REPORT TO THE HEARING EXAMINER

Project Name: CarMax Auto Superstore

File Number: LUA15-000288, ECF, SA-H, MOD, MOD, MOD, VA-A

Project Summary: The applicant is requesting Hearing Examiner Site Plan Review, Environmental (SEPA) Review, three modifications, and a variance for the construction of a new 20,220 square foot CarMax Auto Superstore facility including a dealership, service building, and non-public car wash. The subject property is located on the west side of East Valley Rd between SW 41st St and SW 43rd St at 3157 East Valley Rd. The project site totals 12.28 acres in area and is zoned Commercial Arterial (CA) and Medium Industrial (IM). The site currently contains a 74,000 square foot theater facility which is proposed for removal. There are two primary access points on East Valley Road; a secondary access point on SW 41st St; and a third access point to the west which connects the site to Lind Ave SW. Customer and employee parking, in the amount of 244 parking stalls on the south side of the building. The primary and first phase of sales display area would contain 423 spaces, located on the east side of the property fronting onto East Valley Rd, and secured by highway

EXHIBIT 16

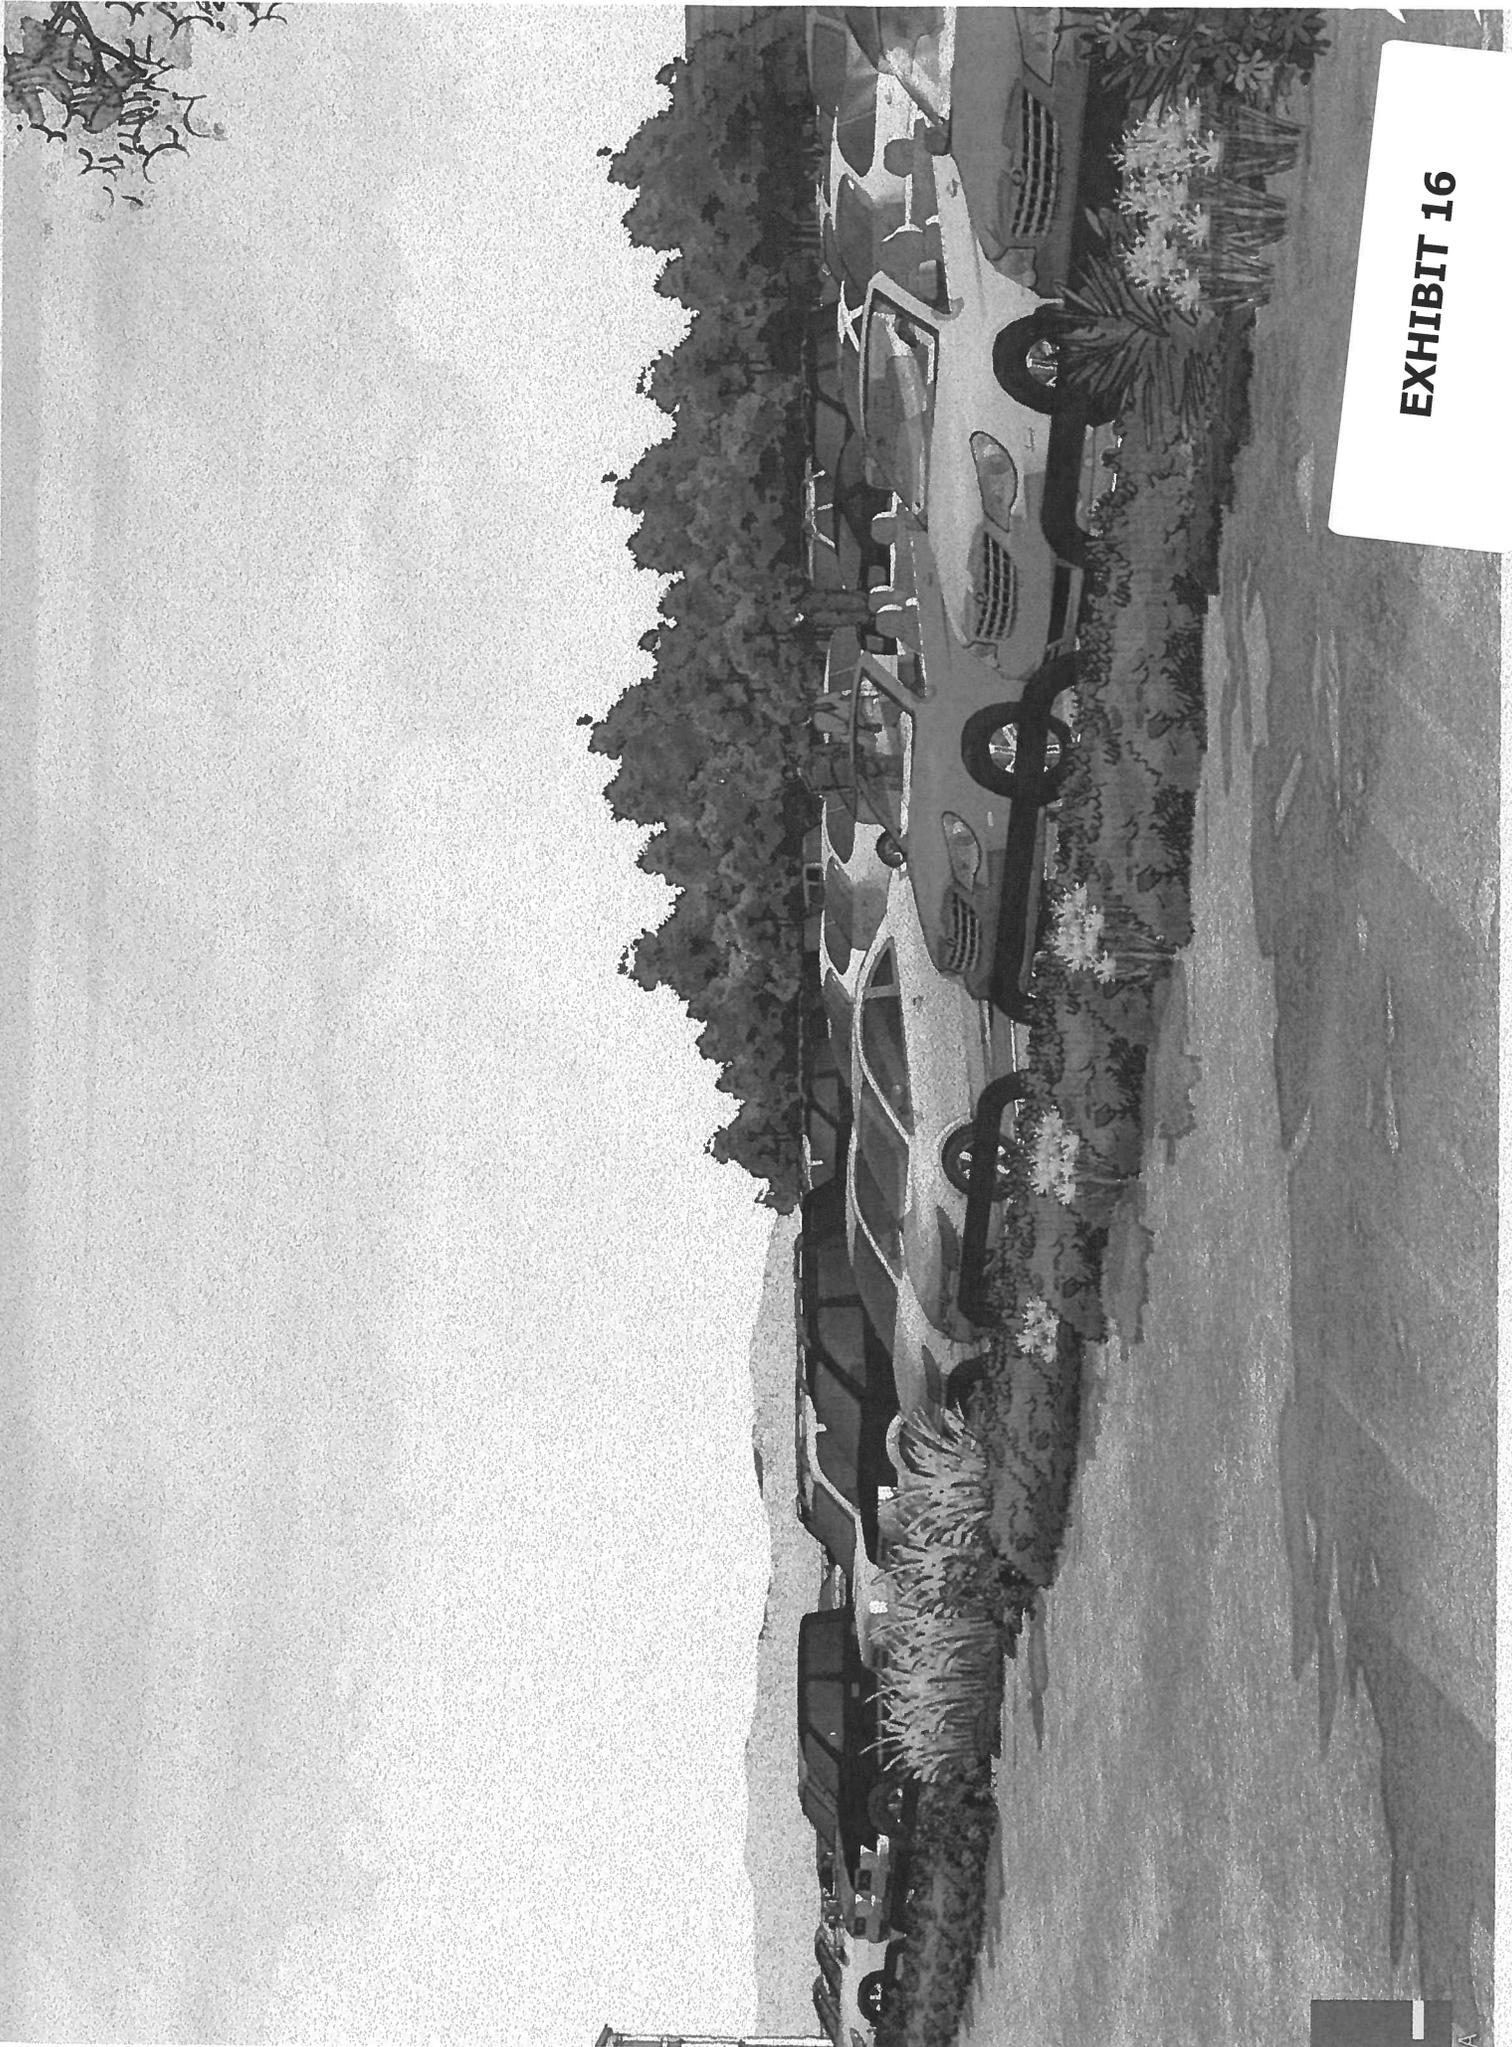
<p>ornamental fencing. A revised landscape plan, with alternative fencing, shall be submitted to, and approved by, the Current Planning Project Manager prior to construction permit approval. The applicant has submitted a bollard alternative to the guardrail which would serve to comply with the recommended condition of approval (Exhibit 16).</p>
<p>b. Structured Parking Garages: <u>Staff Comment:</u> Not applicable.</p>	
<p>c. Vehicular Access: Intent: To maintain a contiguous and uninterrupted sidewalk by minimizing, consolidating, and/or eliminating vehicular access off streets. Guidelines: Vehicular access to parking garages and parking lots shall not impede or interrupt pedestrian mobility. The impacts of curb cuts to pedestrian access on sidewalks shall be minimized.</p>	
<p>✓</p>	<p>Standard: Access to parking lots and garages shall be from alleys, when available. If not available, access shall occur at side streets. <u>Staff Comment:</u> See FOF 31, Site Plan Review Criteria and Analysis: Access.</p>

7. The applicant shall be required to replace the proposed guardrail with ornamental fencing. A revised landscape plan, with alternative fencing, shall be submitted to, and approved by, the Current Planning Project Manager prior to construction permit approval. The applicant has submitted a bollard alternative to the guardrail which would serve to comply with the recommended condition of approval (Exhibit 16).
